MEMORANDUM

TO: MEMBERS OF THE PLANNING COMMISSION
THRU: BARBARA MCBETH, AICP, CITY PLANNER
FROM: SRI RAVALI KOMARAGIRI, PLANNER
SUBJECT: JSP 18-66 FAIRFIELD INN @ ADELL CENTER
DATE: JULY 19, 2019

The purpose of this memo is to provide some background information on the applicant's request for approval of reduction of minimum required parking from 119 spaces to 118 spaces in order to maintain a minimum of 24 feet wide drive aisle.

Previous Layout

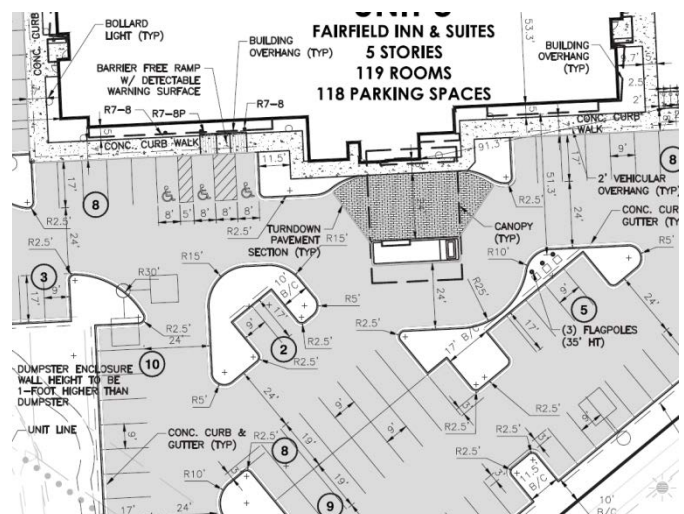
A revision to the site plan to address Traffic comments resulted in reduction of one parking space. It is still within the five percent reduction that is approvable by the Planning Commission. The Planning Commission is asked to approve the minor reduction, supported by staff to allow the applicant to move forward with the site plan approval process.

Stellar Development, LLC (Stellar) is requesting the reduction of one (1) parking space from the site plan in order to comply with the August 6, 2019 traffic review to maintain a clear 24-foot wide travel aisle. The removal of the parking space will still provide the minimum parking required by the PRO standards.
